CPED STAFF REPORT

CPC Agenda Item #5
 August 25, 2014
 BZZ-6660

Property Location: 2309 28th Avenue South
Project Name: Seward Montessori School
Prepared By: [Janelle Widmeier](#), Senior City Planner, (612) 673-3156
Applicant: Minneapolis Public Schools
Project Contact: Andrew Lesch, Minneapolis Public Schools
Request: To expand the existing grade school, which includes three building additions, for a net gross floor area increase of approximately 38,000 square feet.

SITE LAYOUT PLAN

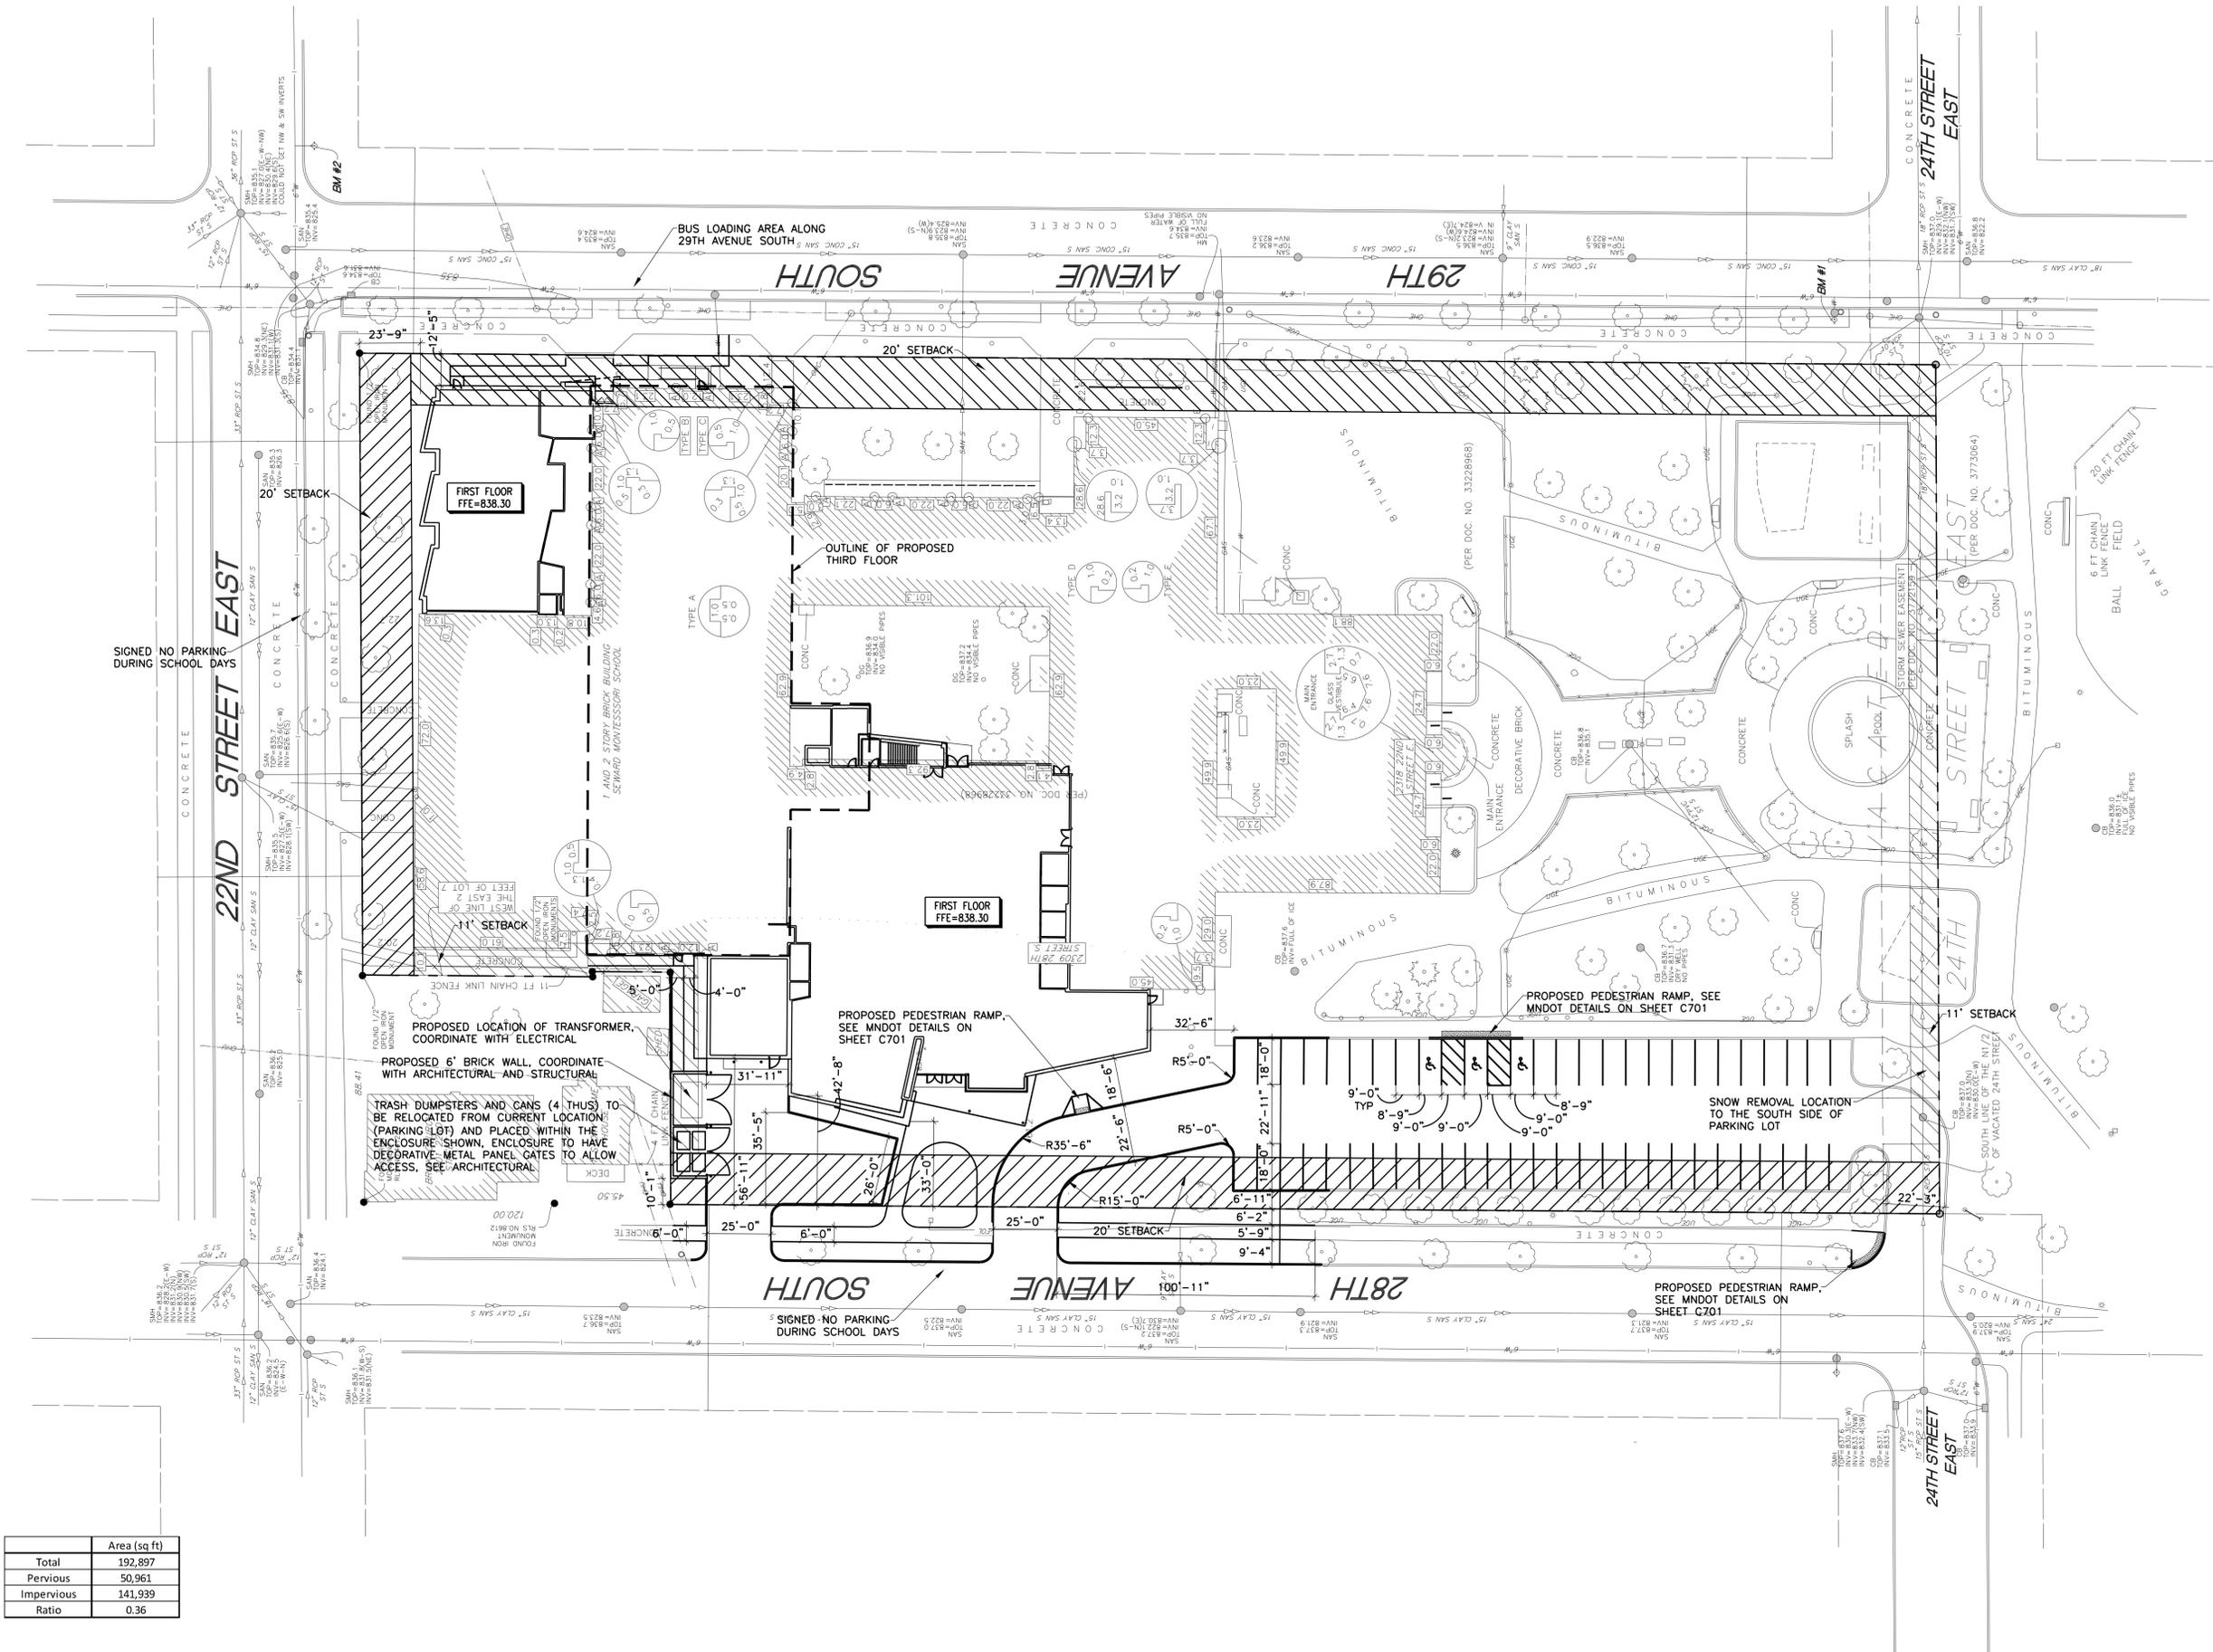
- The applicant is proposing a 28 square foot wall sign on the 28th Avenue building elevation. It would not be illuminated. As shown on the plans, the sign would be placed 18.5 feet above grade. Because there are no authorized variances for signs located in residential zoning districts, the height of the sign will need to be reduced at least 4.5 feet.

- Show the outline of the third floor on the site layout plan.
- A 20 foot wide front yard is required along 29th Ave. The site plan should be updated to reflect this requirement.

EXTERIOR ELEVATIONS

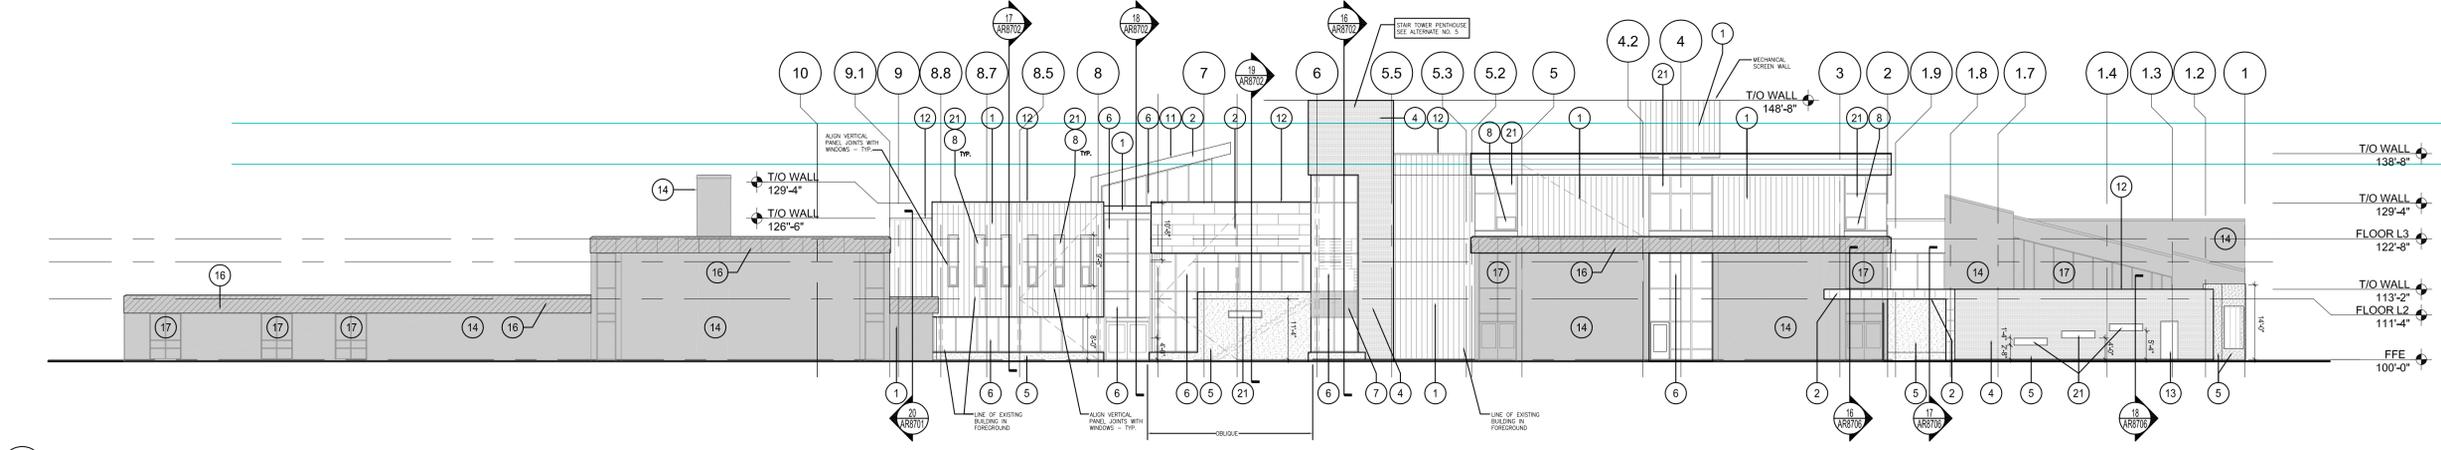
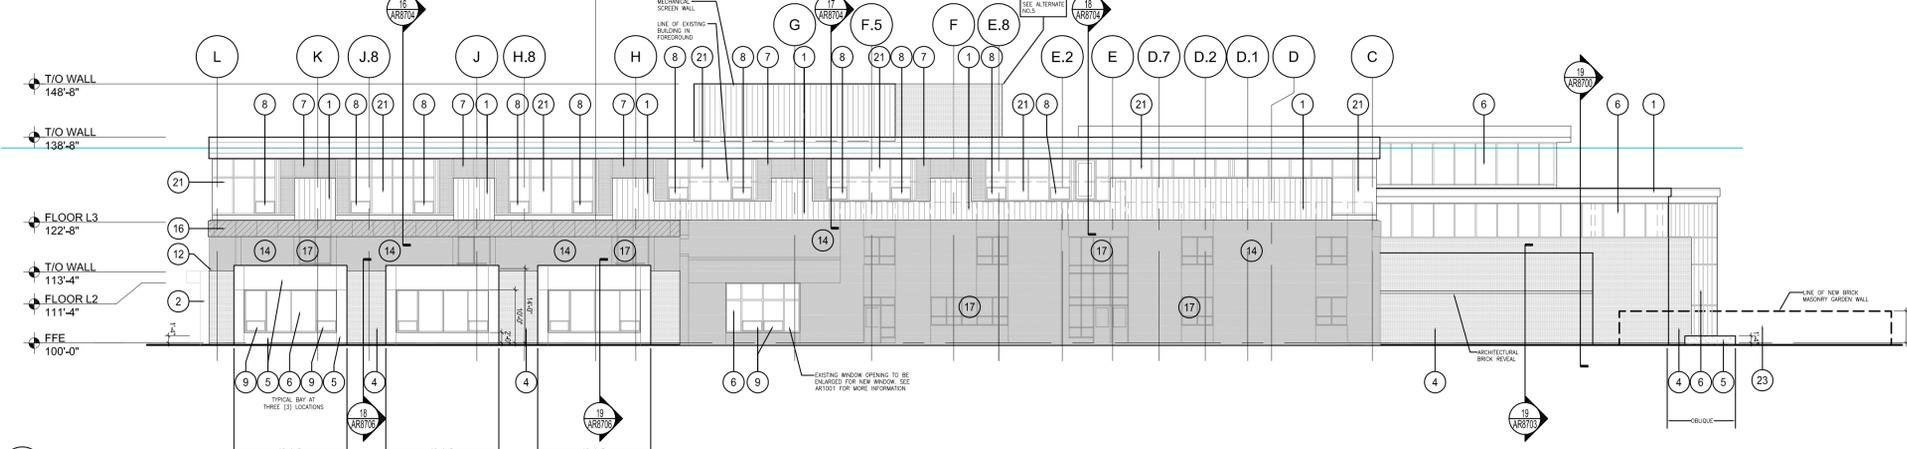
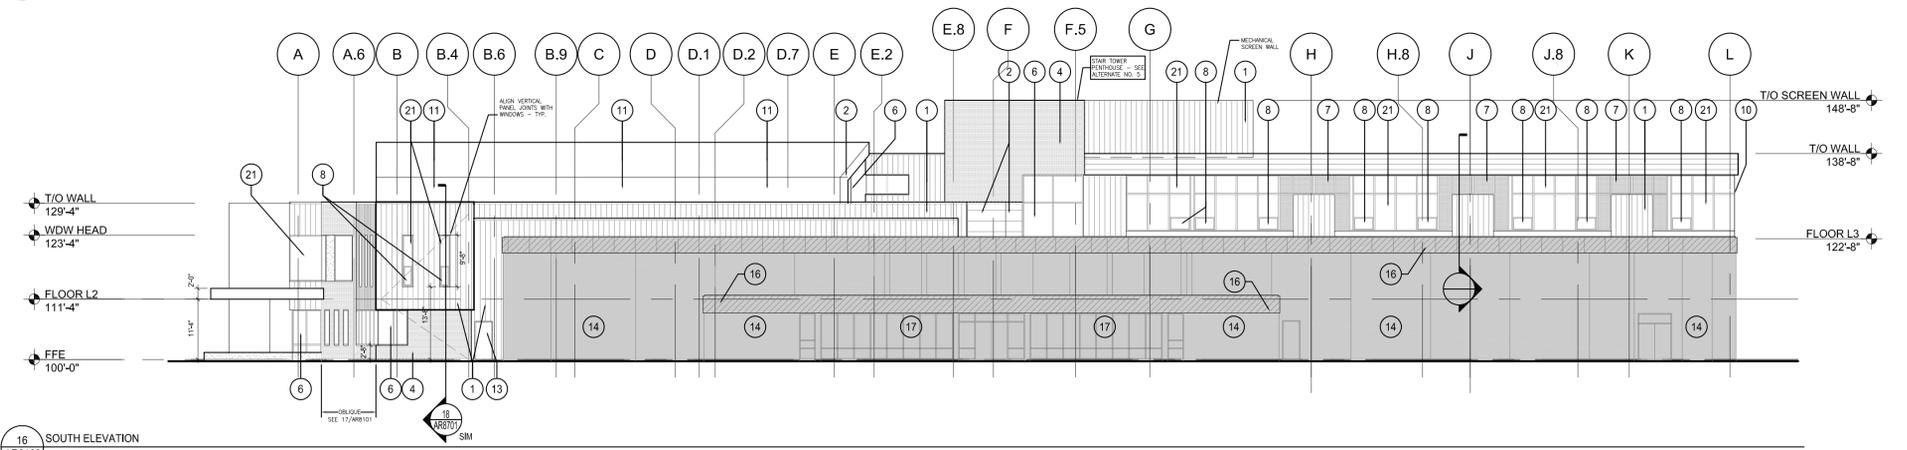
- Provide an architectural building demolition plan.
- Show lot line locations on the floor plans.
- Walls without architectural elements are not allowed to exceed 25 feet in width per section 530.120 of the zoning code unless alternative compliance is granted. A blank wall 40 feet in width is proposed on the north wall facing the interior lot line.
